CITY OF ALBUQUERQUE

Re: Brewstiller
500 Yale SE
Traffic Circulation Layout
Architect's Stamp dated 02-05-16 (K15-D099)

Based upon the information provided in your submittal received 08-31-16, the above referenced plan cannot be approved for Building Permit until the following comments are addressed:

SHEET NO:
A1.2

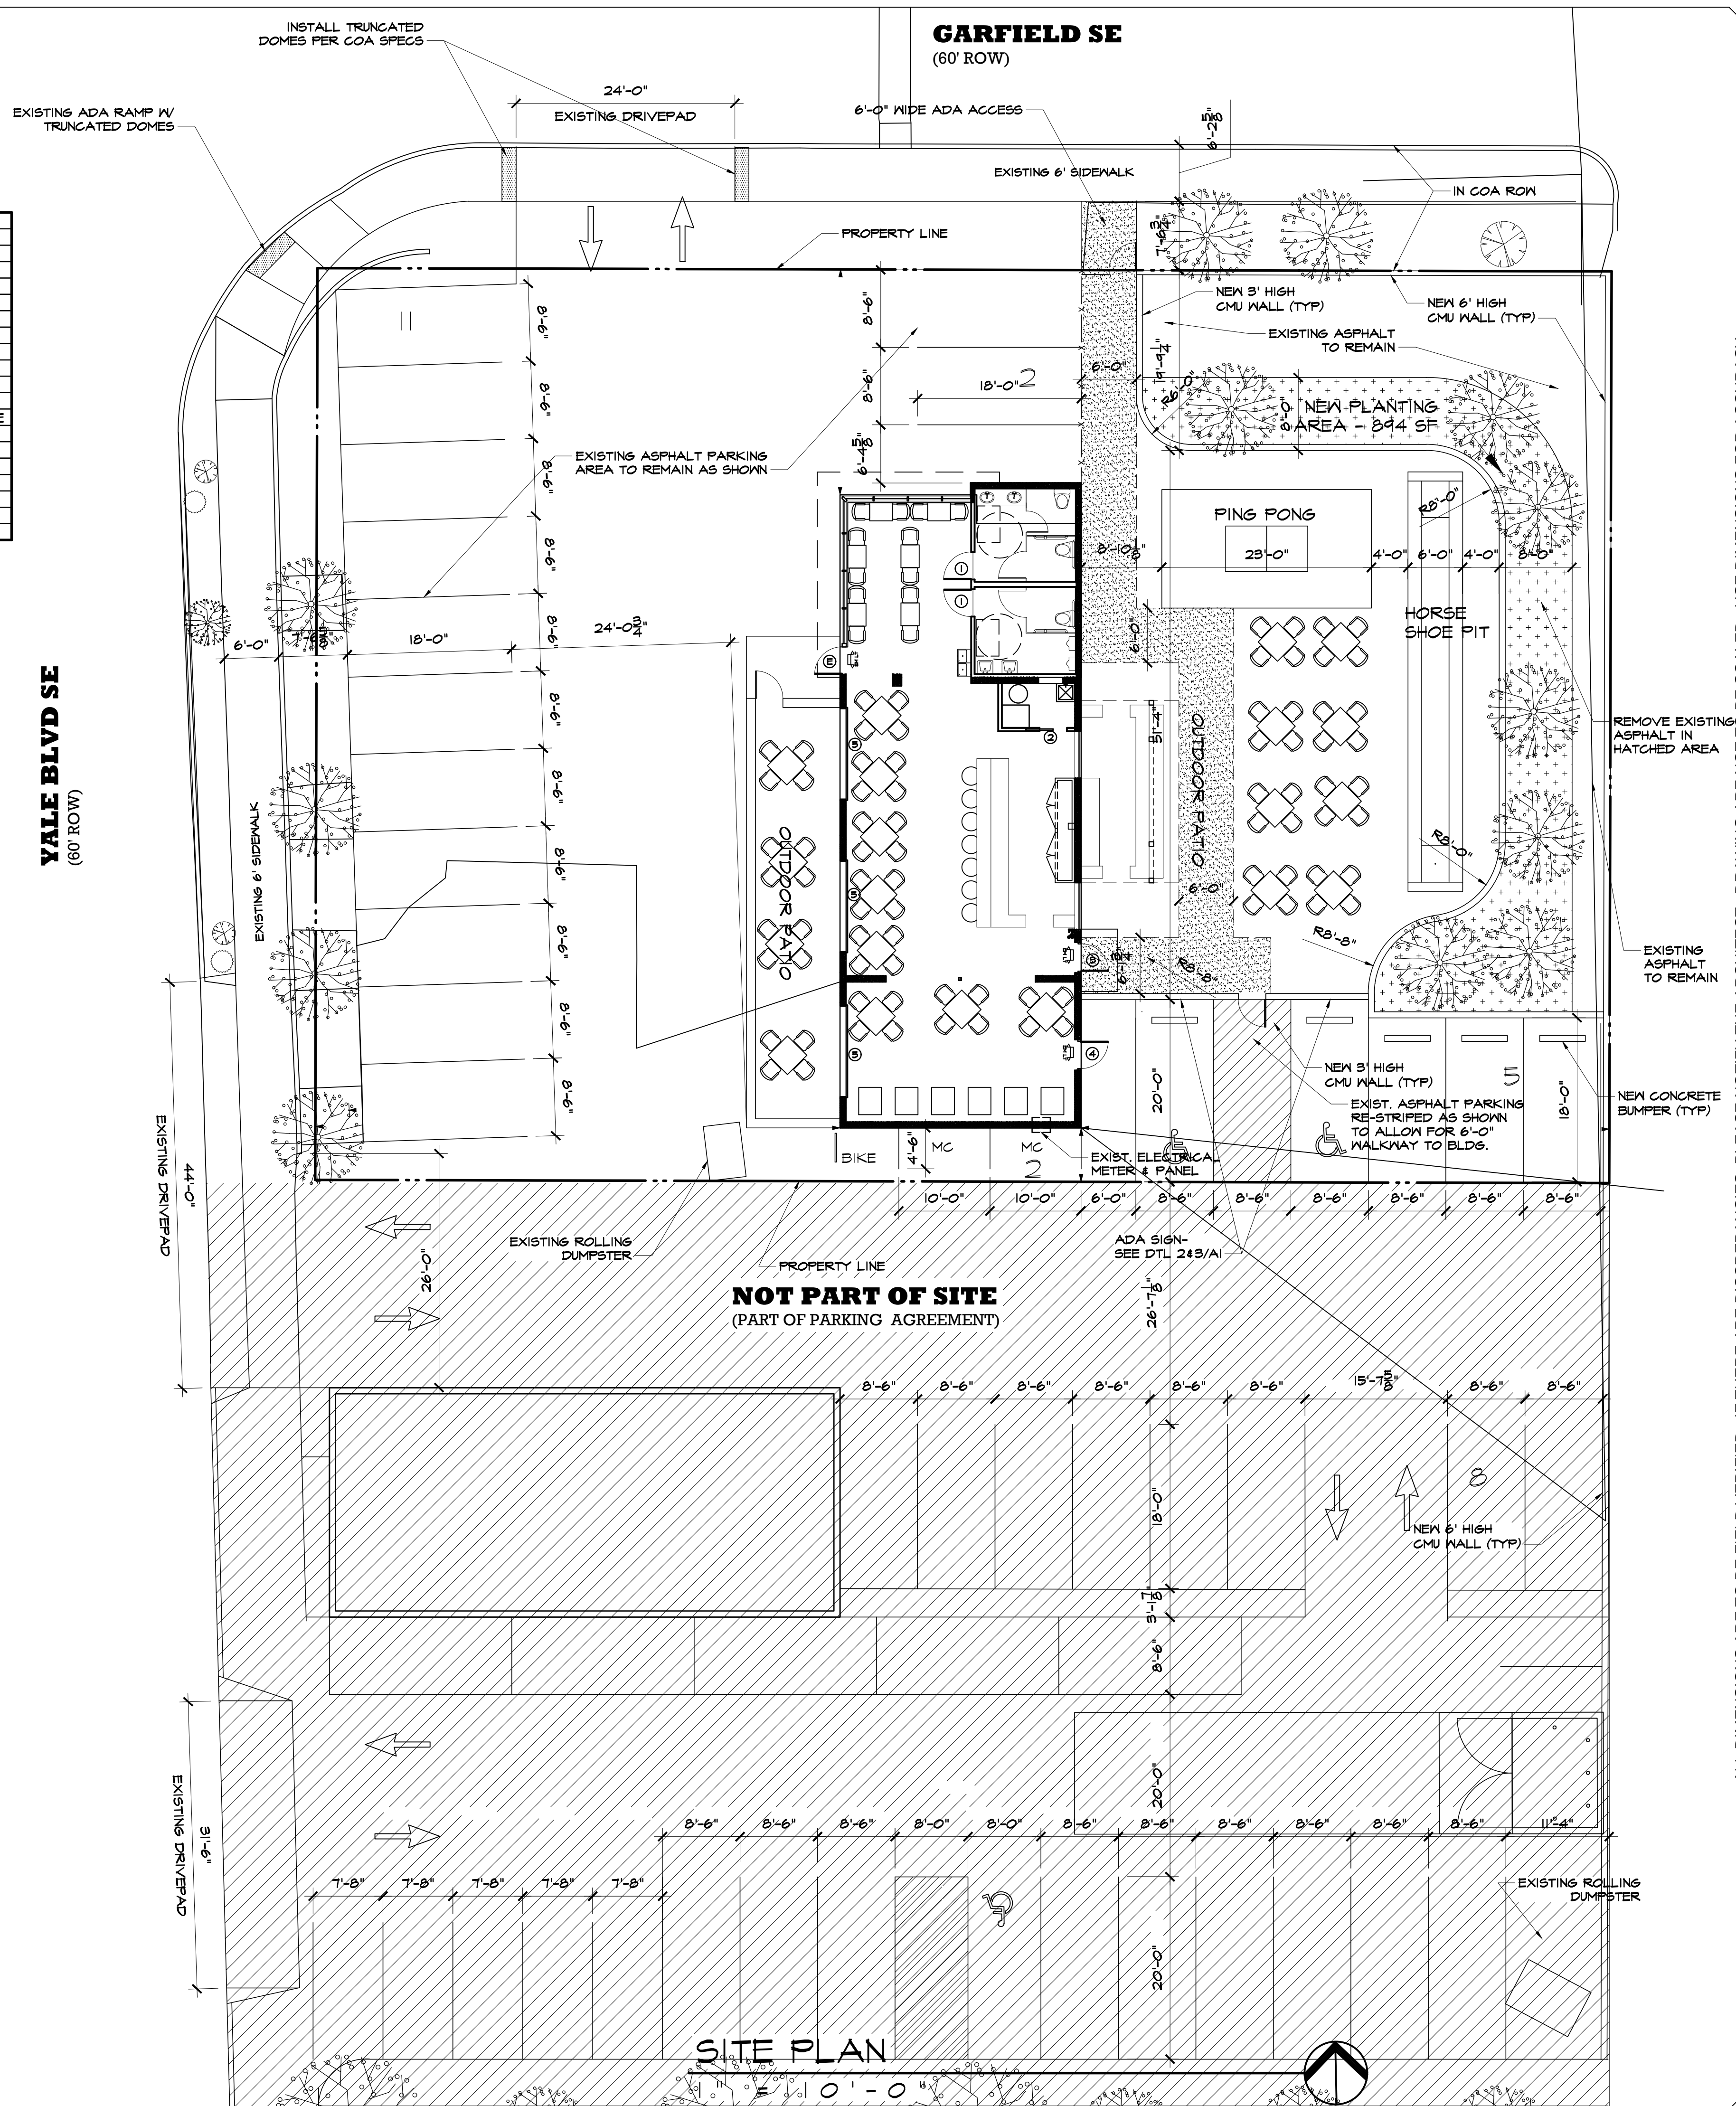
1. The ADA access aisles shall have the words "**NO PARKING**" in capital letters, each of which shall be at least one foot high and at least two inches wide, placed at the rear of the parking space so as to be close to where an adjacent vehicle's rear tire would be placed. (66-1-4.1.B NMSA 1978)
2. The existing curb cut on Yale Blvd must be reconstructed to match the existing dimension of the drive aisle on the property. It must be replaced with sidewalk and curb & gutter. A build note must be provided referring to the appropriate City Standard drawing.
3. Add a note stating "All broken or cracked sidewalk must be replaced with sidewalk and curb & gutter." A build note must be provided referring to the appropriate City Standard drawing.
4. Please include two copies of the traffic circulation layout at the next submittal.
